Get the Right Tire Chains

Tire chains can come in handy for your Stryker when winter weather arrives. But the chains were left out of some of the -10 TM additional authorized lists (AAL), while one other lists the wrong chain.

Use proper
tire chains
on your
Stryker

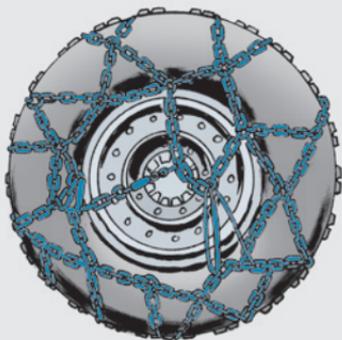
UNTIL
THE NEXT
UPDATE,
ADD THIS
CHAIN TO THE
AAL OF THE
FOLLOWING
TMS...

- TM 9-2355-311-10-2, M1126 RV
- TM 9-2355-311-10-4, M1130 CV
- TM 9-2355-311-10-5, M1127 RSV
- TM 9-2355-311-10-6-2, M1132 ESV
- TM 9-2355-311-10-7, M1134 ATGM
- TM 9-2355-311-10-8, M1133 MEV
- TM 9-2355-311-10-9, M1131 FSV

TM 9-2355-311-10-3, the M1129E1 MC (B Variant) lists the wrong tire chain, NSN 2540-21-914-4252, in the AAL. This is a 0.5-mm chain that's actually made for the Marine Corps LAV. It won't fit properly on the Stryker and doesn't last very long, so scratch it out and replace it with NSN 2540-01-498-8821.

The correct NSN for Stryker tire chains is 2540-01-498-8821. This is a 0.8-mm chain that's made of high-grade material and fits the Stryker's tires perfectly.
